# Independent Review Team Final Report

East Span San Francisco Oakland Bay Bridge Seismic Safety Project

November 19, 2004

Contract No. 53A0063 Task Order No. 330

CS ALTERNATE 1: 180m-385m TWO SPAN LAYOUT **GENERAL PLAN & ELEVATION**

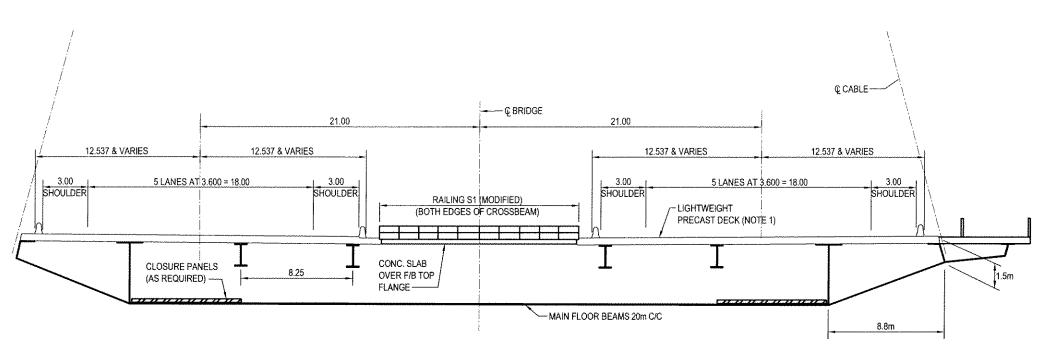
- 1. **General:** The analysis is based on conservative assumptions with respect to key elements such as the superstructure weight, tower weight, and tower stiffness. The demands for the foundations and towers during the next stage of design development are expected to be lower than those predicted at this stage.

- 2. **Foundations:** The analysis shows that the existing T1 and E2 foundations can be used as-is for Alternate 1. Furthermore, there is additional reserve pile capacity of nearly 48% at T1 and 25% at E2. It is hard to anticipate a reason for needing more piles based on the analysis data. However, should additional capacity be needed, additional piles can be added without increasing the existing foundation footprints.

- 4. **Tower Design:** The concrete towers can be designed to meet the seismic performance requirements of the project using less than 4% rebar steel as required by ATC-32. Also, the limits on tower concrete and steel strains assumed for the present study show that the tower can be designed to a seismic performance standard equal to or exceeding those adopted for the SAS tower design.

- 6. **Interface Forces and Movements:** The analysis results show that the existing hinge design and details can be used with little or no change.

CS ALTERNATE 2: 180m-225m TWO SPAN LAYOUT **GENERAL PLAN & ELEVATION**

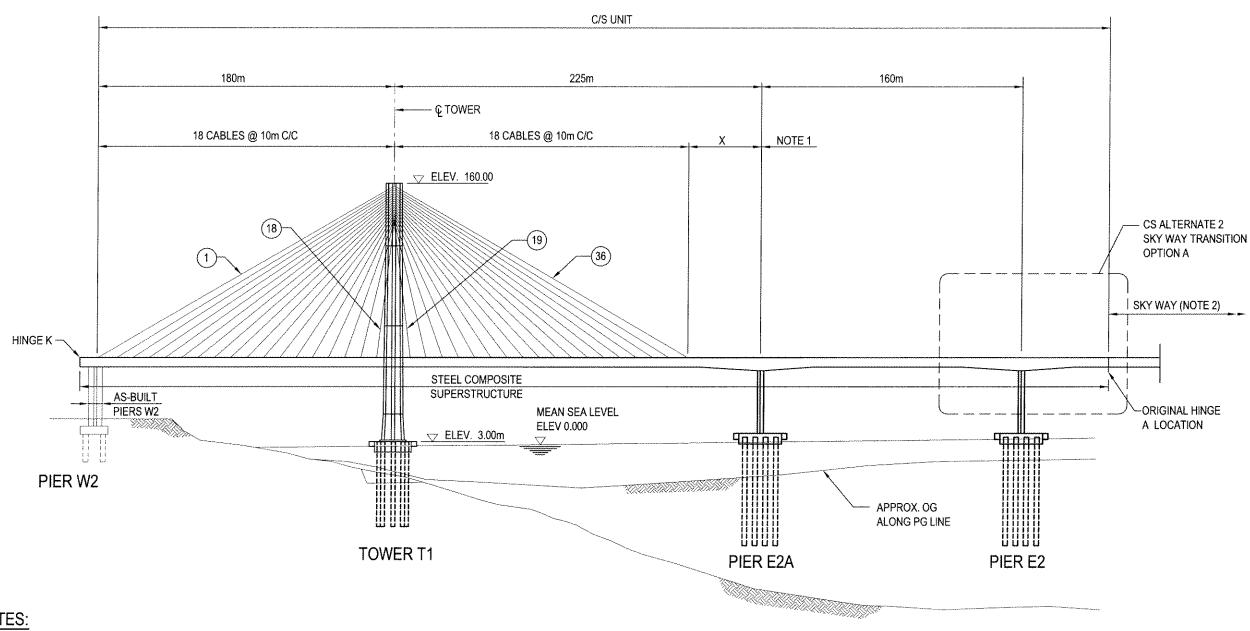
The back span and the main span for this option are balanced about the tower, and this alternate is a simpler design for that reason. It is expected that for Option A, foundations at T1 and E2 (E2A would be similar to E2) could be reduced approximately by 40 to 50% of their size, compared to the SAS. For Option B, foundation T1 could be reduced by 40 to 50% compared to SAS and piers E2 and E2A would be similar to that at E3.

- 3. **Tower Design:** The concrete towers can be designed to meet the seismic performance requirements of the project using less than 4% rebar steel as required by ATC-32. Also, the limits on tower concrete and steel strains assumed for the present study show that the tower can be designed to a seismic performance standard far exceeding those adopted for the SAS tower design.

- 5. **Interface Forces & Movements:** It is expected that the existing hinge design and details can be used with little or no change.

CS ALTERNATE 3: 140m - 385m - 140m 3 SPAN LAYOUT **GENERAL PLAN & ELEVATION**

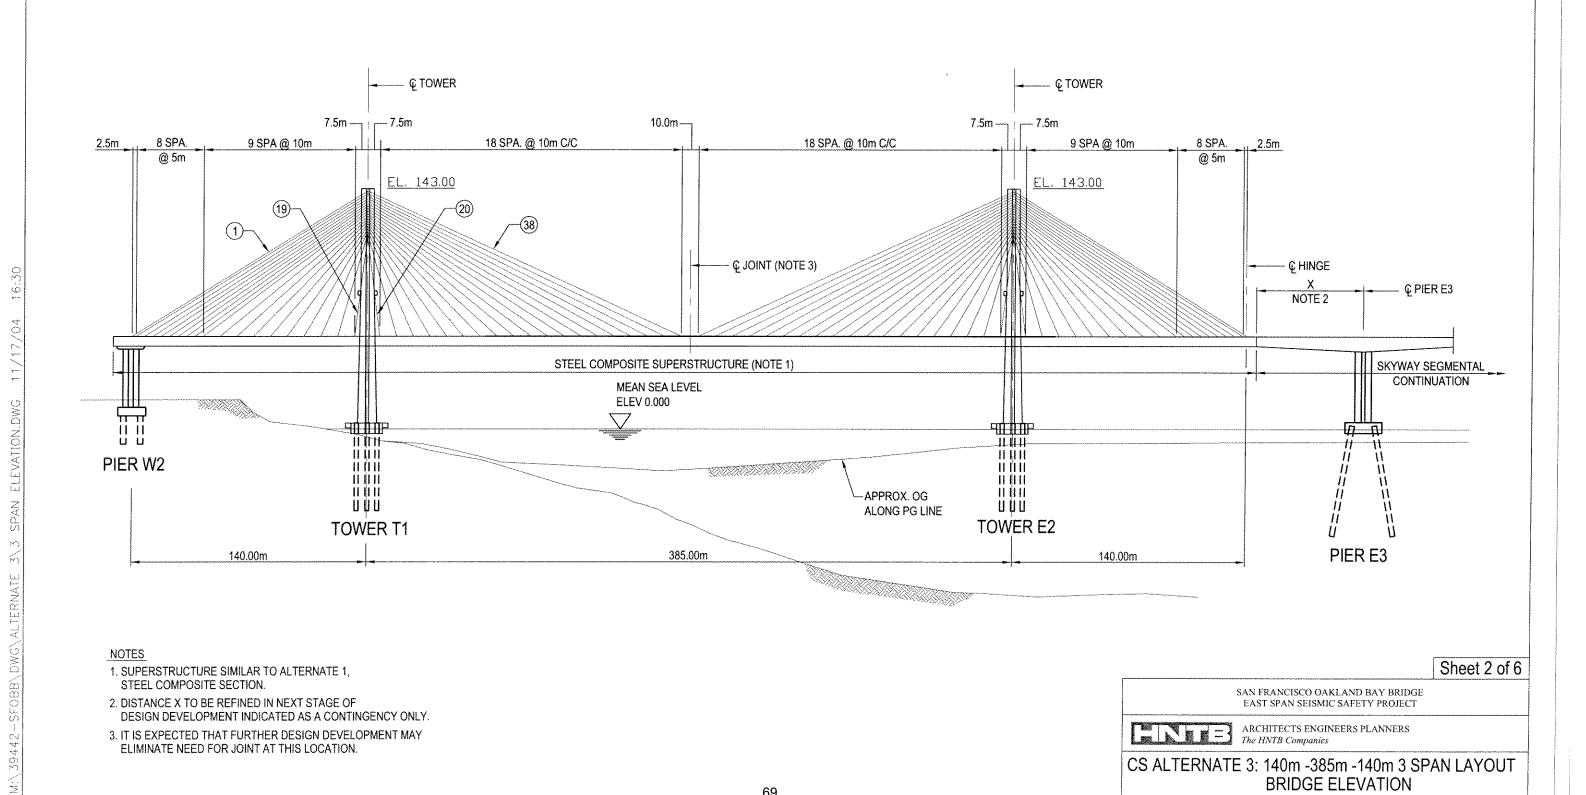
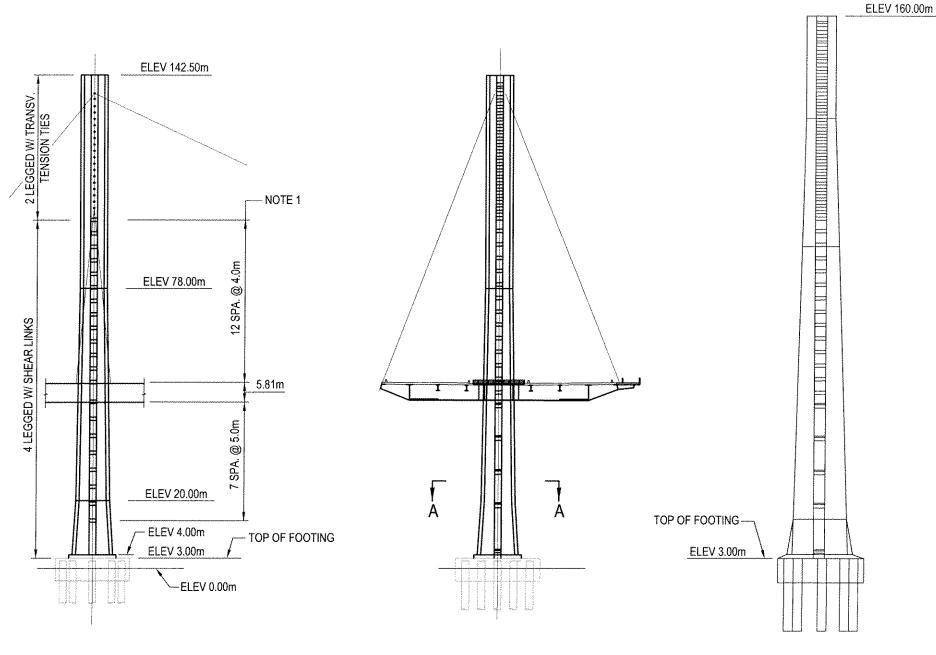
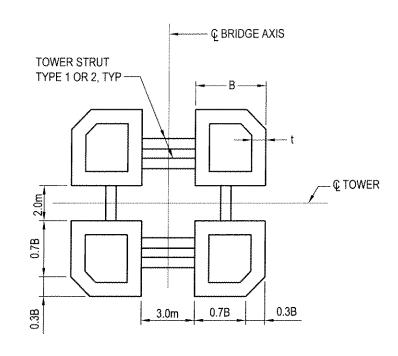
- 1. **General:** The analysis is based on conservative assumptions with respect to key elements such as the superstructure weight, tower weight, and tower stiffness. The demands for the foundations and towers during the next stage of design development are expected to be lower than those predicted at this stage. This alternate requires some further design refinements to resolve a couple of remaining issues. However, the key issues such as the foundation sizes and the concrete tower performance have been confirmed.

- 2. **Foundations:** The analysis shows that the existing T1 and E2 foundations can be used as-is for Alternate 3. However, to achieve the best bridge layout it is our opinion that the tower foundations must be properly redesigned to make them more proportional to the structure.

- 4. **Tower Design:** The concrete towers can be designed to meet the seismic performance requirements of the project using less than 4% rebar steel as required by ATC-32. Also, the limits on tower concrete and steel strains assumed for the present study show that the tower can be designed to a seismic performance standard far exceeding those adopted for the SAS tower design.
